DEMOLISH EXISTING 4-PLEX STRUCTURE & CONSTRUCT NEW TWO STORY DUPLEX-MONOLITHIC FOUNDATION, CBS MASONRY WALLS, HOLLOW CORE PLANKS & WOOD ROOF TRUSSES WITH 1HR RATED SEPARATION WALL.

REVISED 5/22/23 AS PER HPB COMMENTS:

THIS DRAWING IS NOT FOR CONSTRUCTION. IT HAS BEEN ISSUED FOR GOVERNMENTAL REVIEW AND/OR PRELIMINARY PRICING.

## PROPOSED SITE PLAN

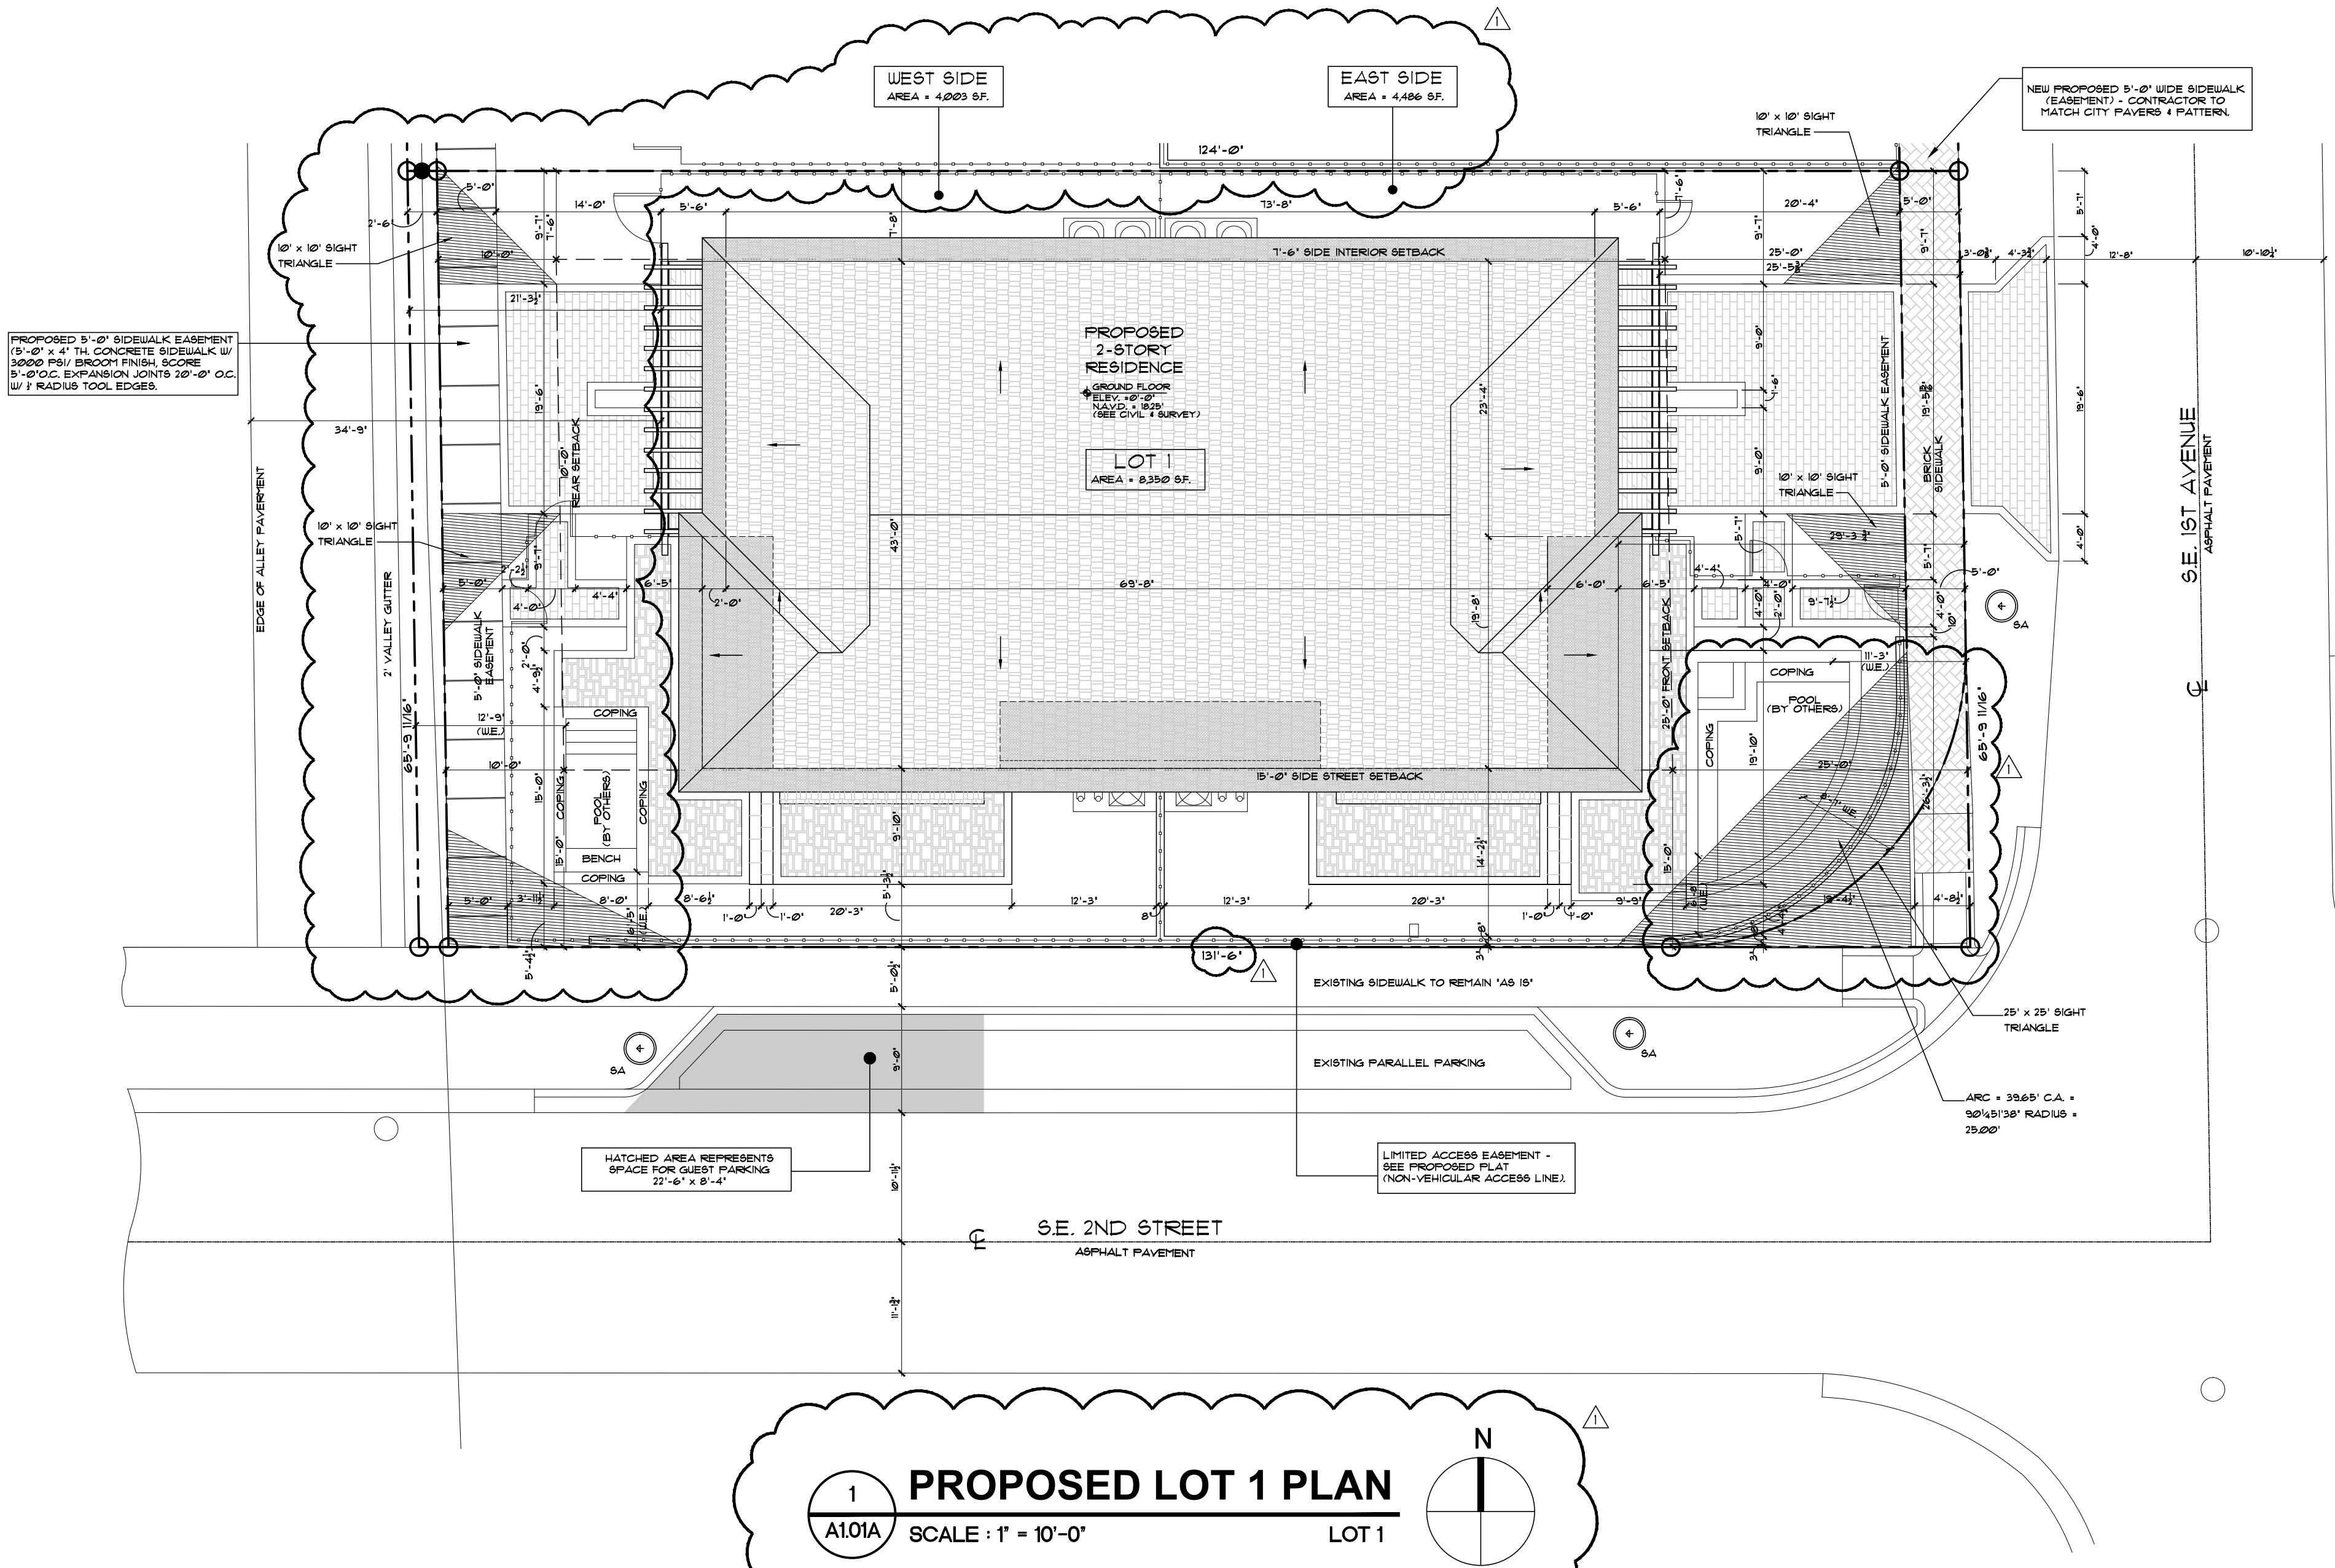
1. PROPOSED SITE PLAN FOR EACH UNIT IS NOW LISTED AS FIRST PAGE IN THE SET.

2. RELABELED DRAWINGS FROM "MASTER PLAN" TO "OVERALL" SITE PLANS.

3. PROPOSED OVERALL SITE PLAN IS NOW ONLY SHOWN AT 1" x 20'-0".

## ARCHITECTURAL CONTEXT PLAN

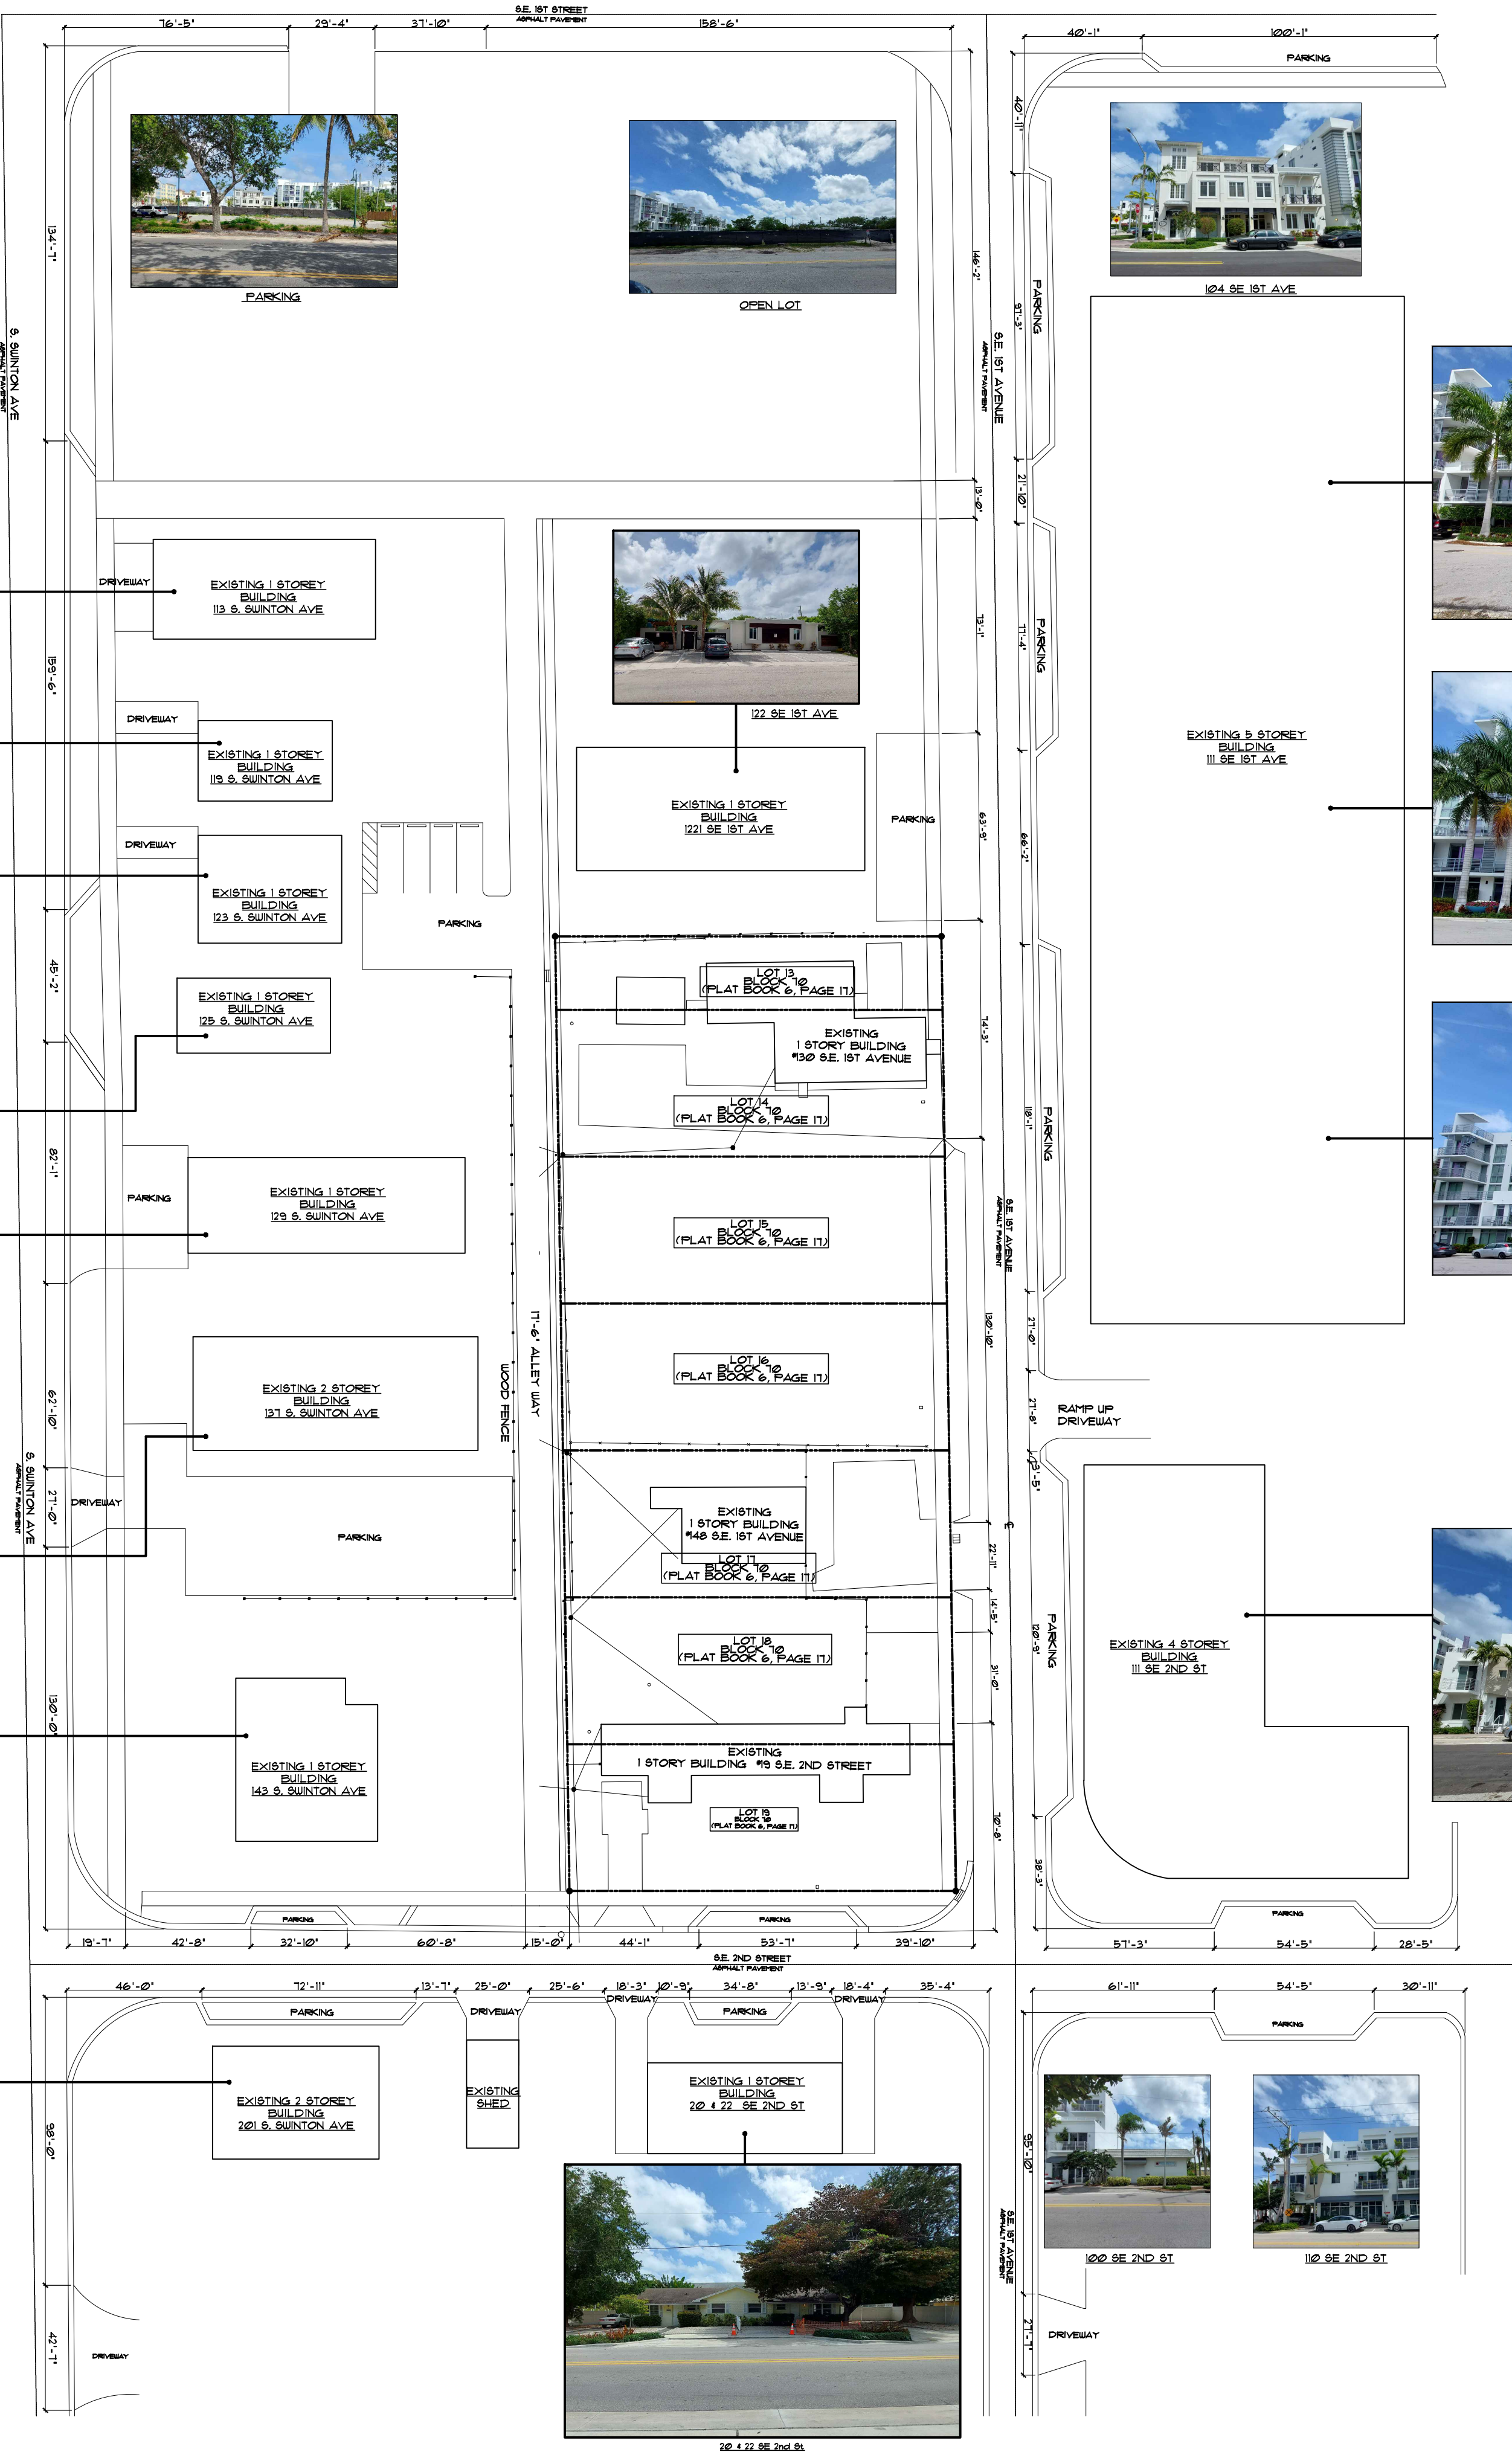
- REVISOR: 5/22/23 AS PER H.P.B. COMMENTS.
1. ROTATE PLAN TO SHOW SITE ORIENTED WITH NORTH TO THE TOP OF THE PAGE
  2. LOCATION OF DRIVEWAYS OF ADJACENT PROPERTIES HAVE BEEN LABELED.
  3. APPROXIMATE LOCATION OF SURROUNDING STRUCTURES ADDED TO DRAWING.

PROPOSED  
GROUND  
FLOOR PLAN  
LOTS 2 AND 4

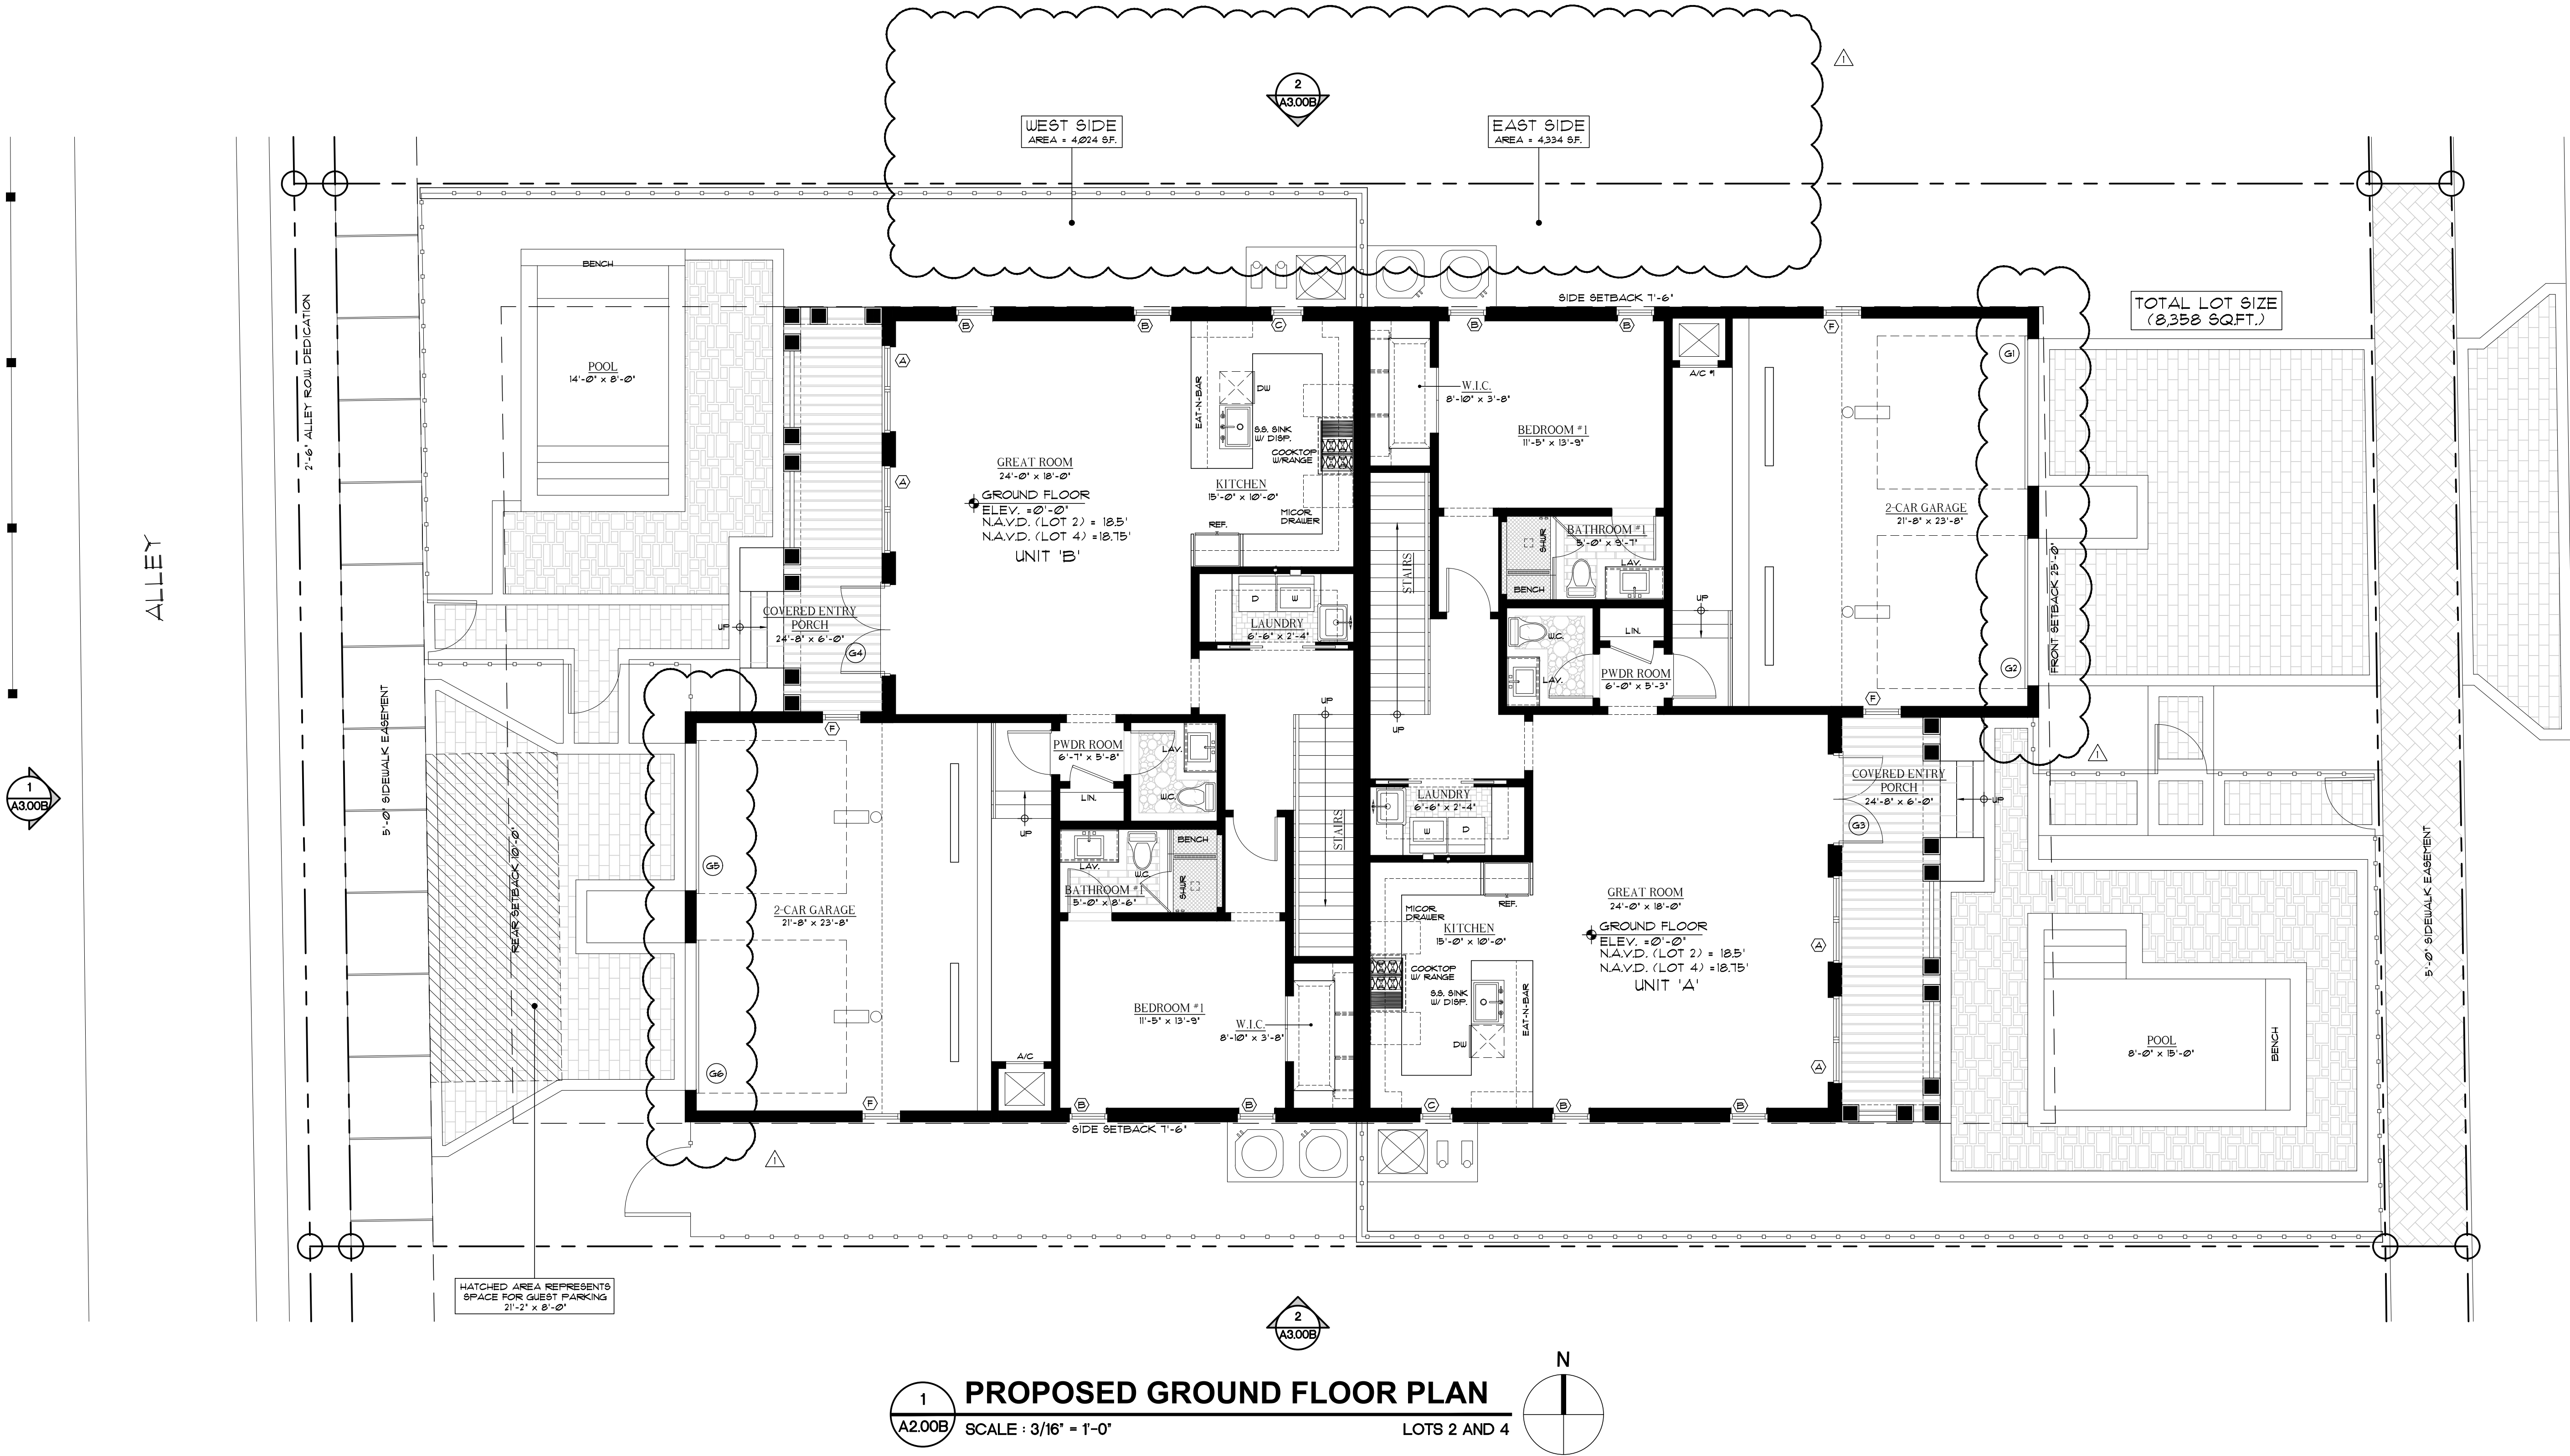
REVISIONS:  
REVISED 8/22/23 AS PER H.P.D.  
COMMENTS:  
1. DUPLEX PLANS HAVE BEEN  
MODIFIED IN ORDER TO MEET 4,000  
SF DUPLEX LOT REQUIREMENT.
